# 42 HONEYSUCKLE DRIVE COTTAGE CREEK PRECINCT NEWCASTLE

STATE SIGNIFICANT DEVELOPMENT (SSD-10378)  
DEVELOPMENT MODIFICATION 2

ARCHITECTURAL DESIGN STATEMENT

NOVEMBER 2021

# 5.1 DESIGN CHANGES EIGHT FLOOR

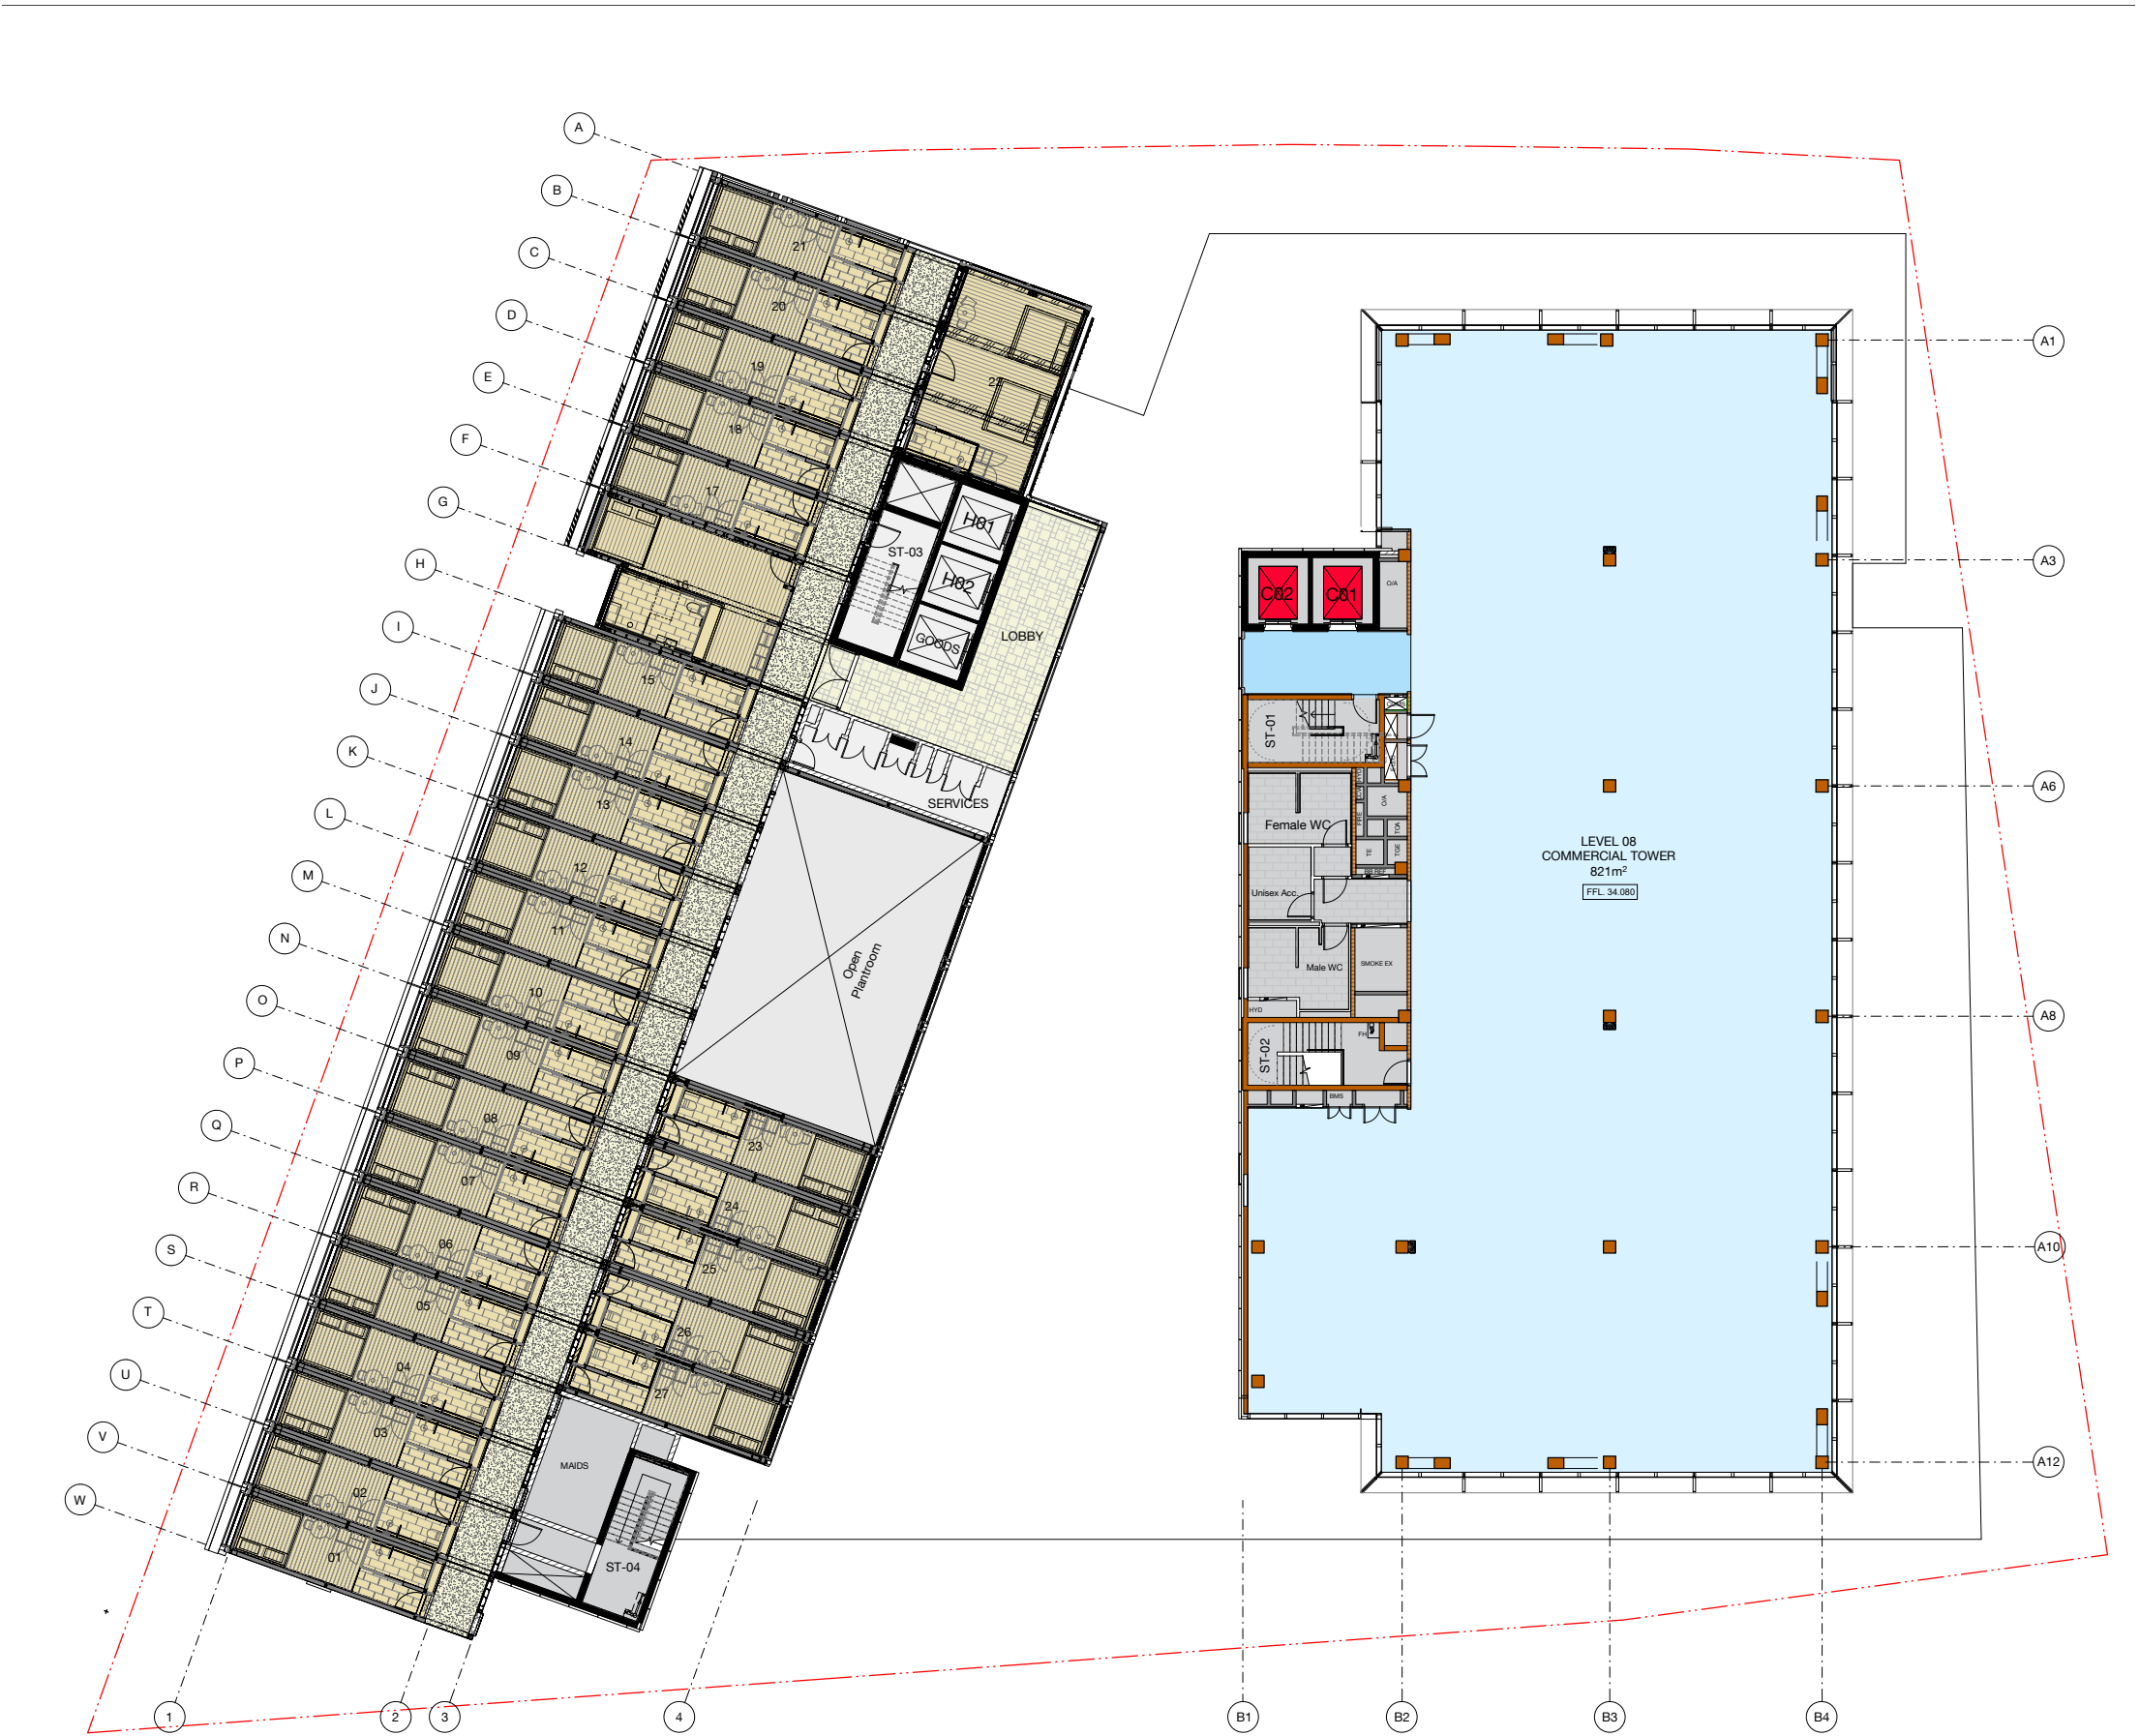
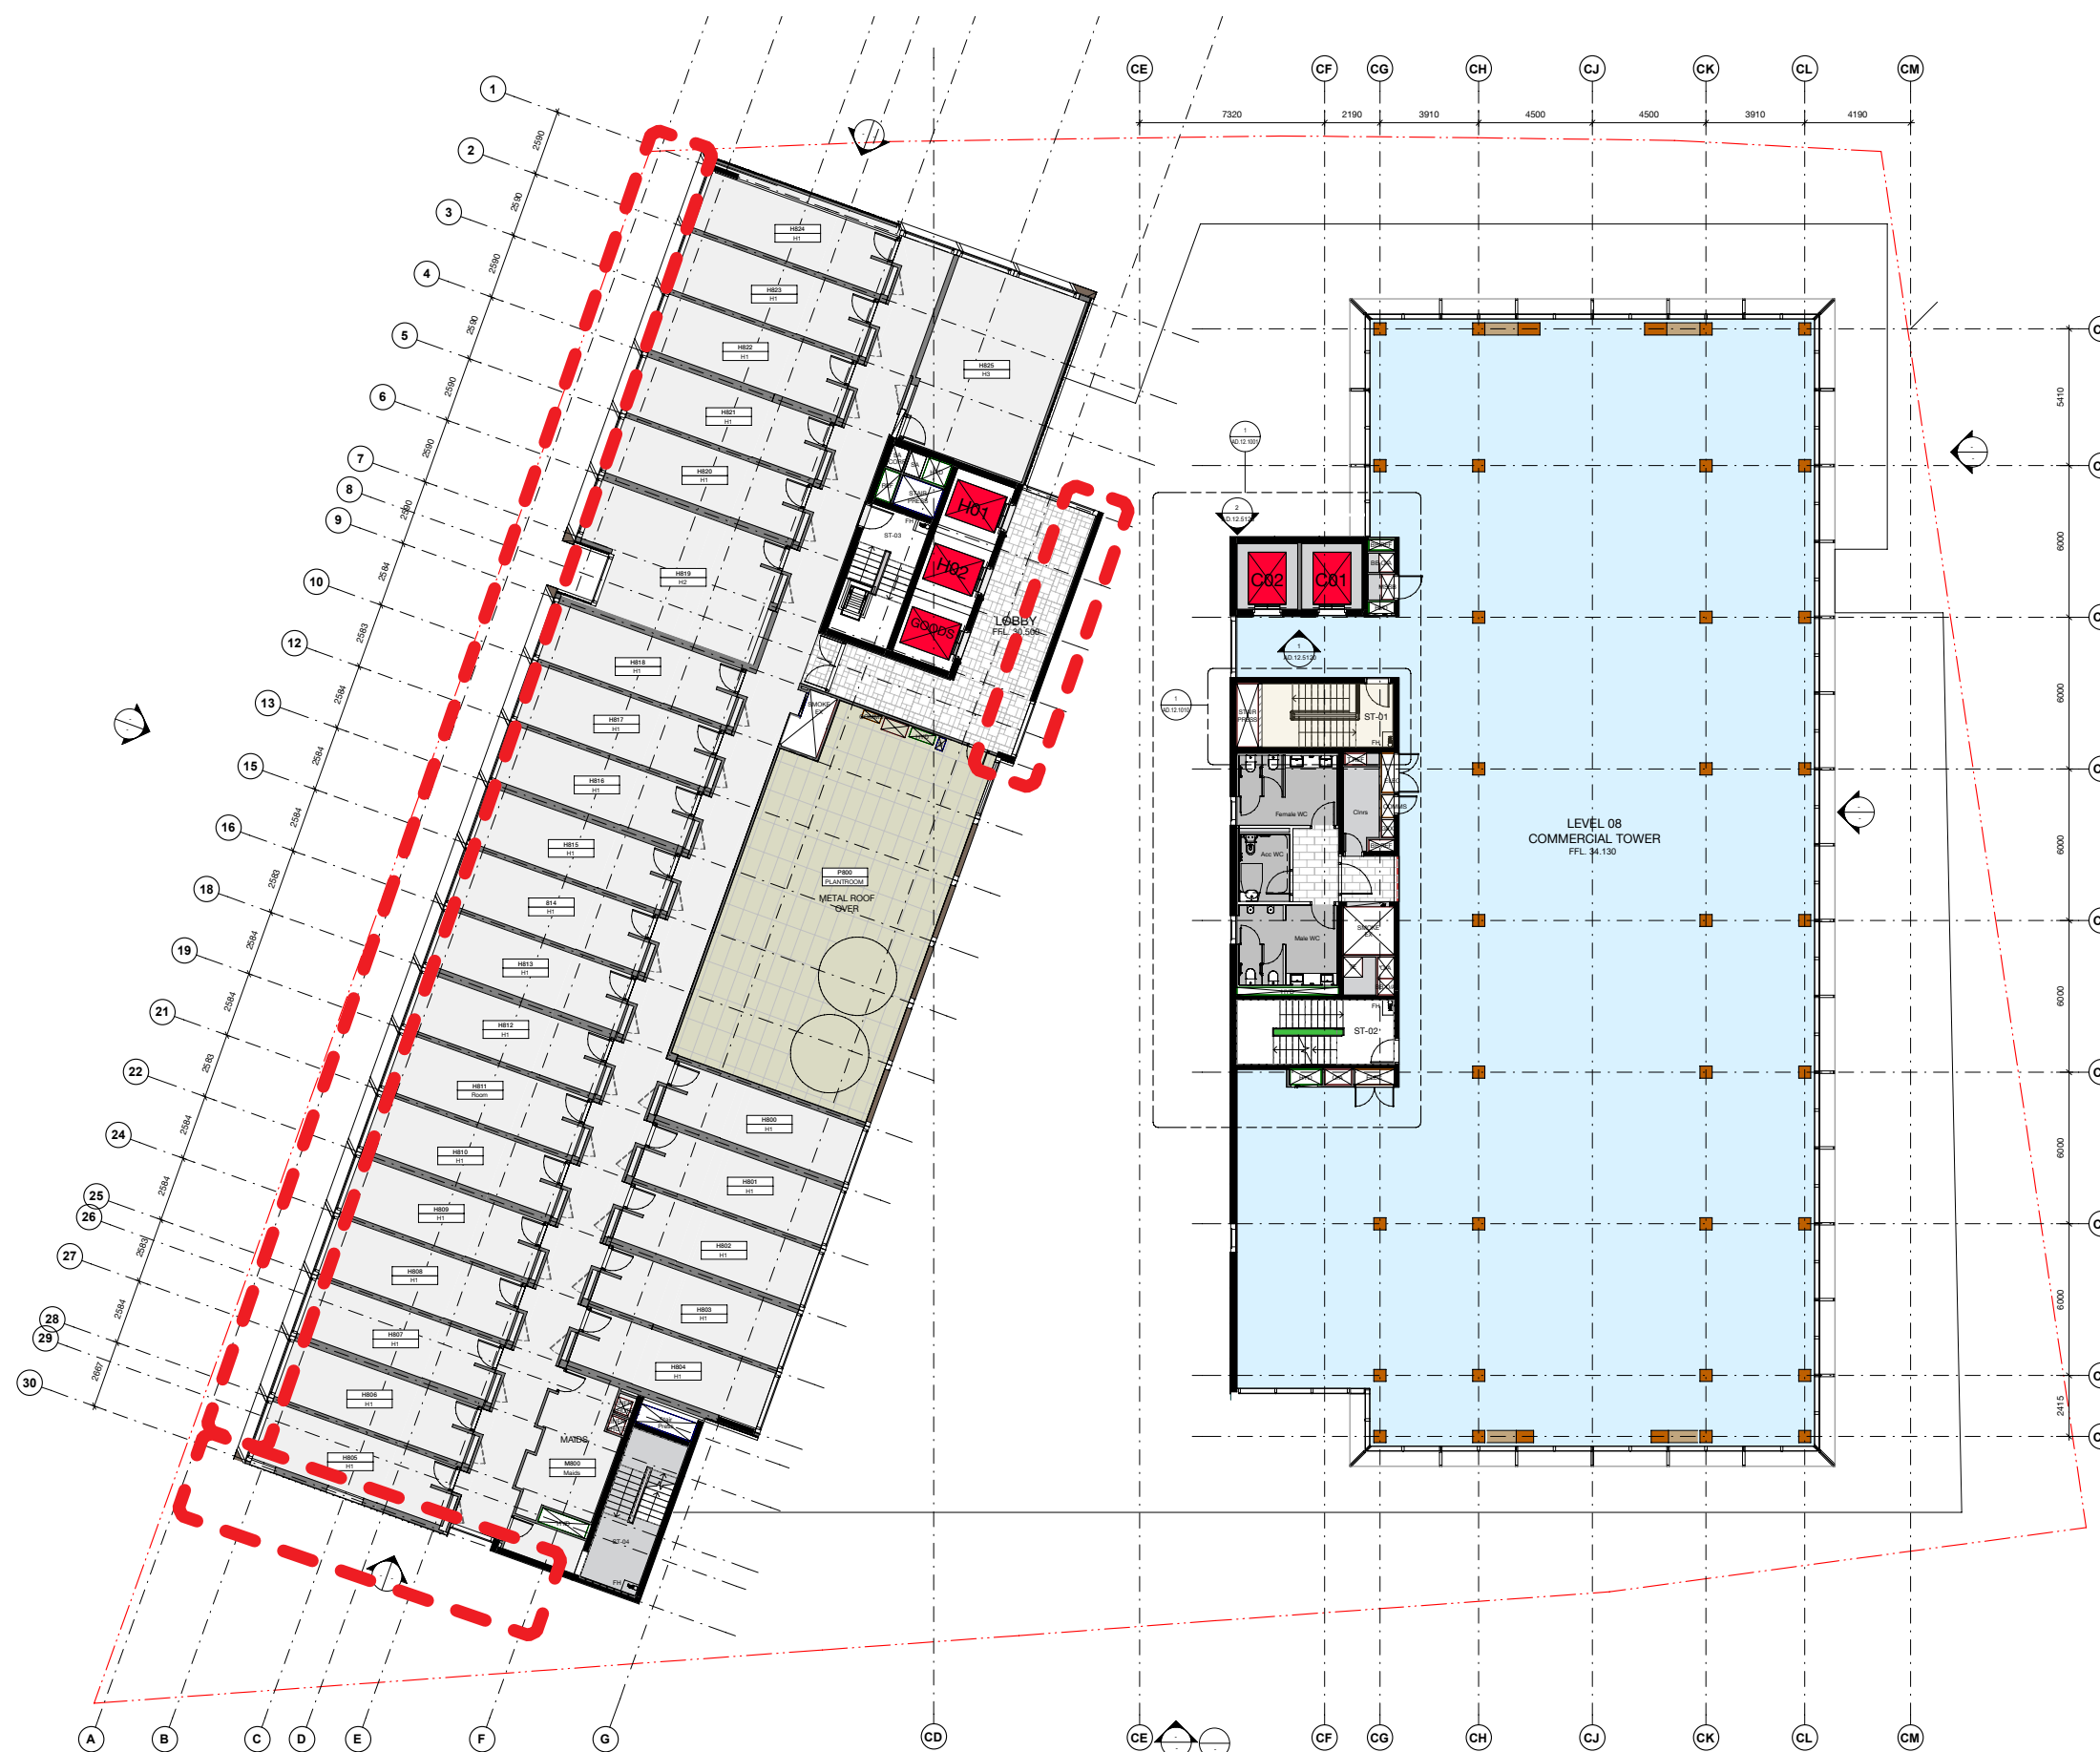
1 / South west end of the hotel - 1 room from every level omitted.

2 / Western hotel facade sunshading design amended

3 / Hotel modular construction methodology amended to a traditional built form.

4 / Facade amended outside lift lobby. This is now concrete construction rather than glazing to increase privacy between the hotel and commercial tower.
